BASIC COMMERCIAL DESIGN CRITERIA

Chapter 18.110

PLANNER RESPONSES

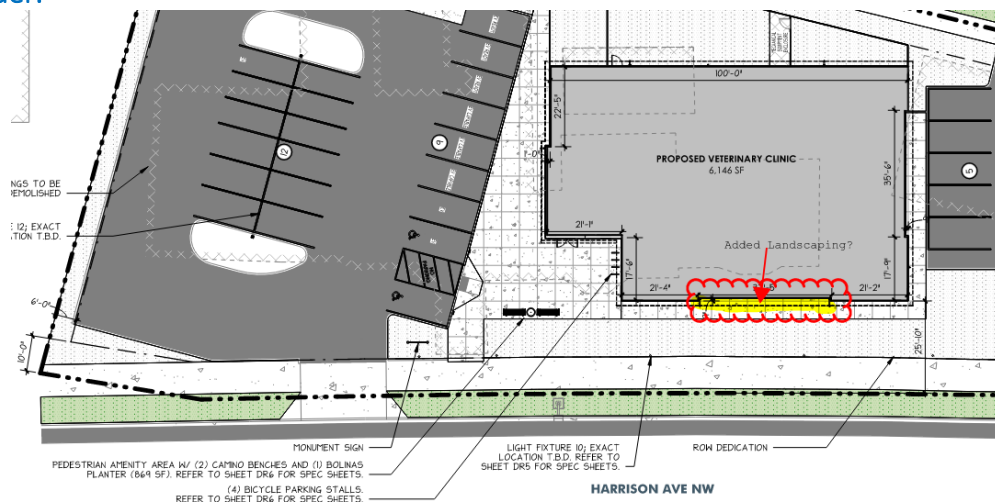
Staff Response: It appears that the applicant is proposing to substitute glazing for other building elements to meet requirement as the glass is not comprised of 60% of the building face. Staff identified the following:

- Exterior architectural details through use of different exterior materials are being used on the building but the mid wall section exceeds 30 feet in length. It is interpreted that wall segments should have different architectural details, such as material changes every 30 feet in length.
- No landscaping or climbing plants are proposed adjacent to the building and screening of the wall that is over 30 feet is not achieved.
- A pedestrian area is being provided upon at the southwest entry point adjacent to Harrison Avenue with landscaping and seating benches.

The applicant provides elements from each section of the listed preferences but one of the walls is over 30 feet in length. The Board may want to discuss what could be done to the wall over 30 feet in length. Perimeter landscaping is provided along the front adjacent to the public sidewalk but the Board may want to discuss if this provides adequate screening of that section of the wall. Staff suggests that adding some landscaping adjacent to that wall section (highlighted area below) may be better suited. A condition in the staff report is provided for the Board to consider.
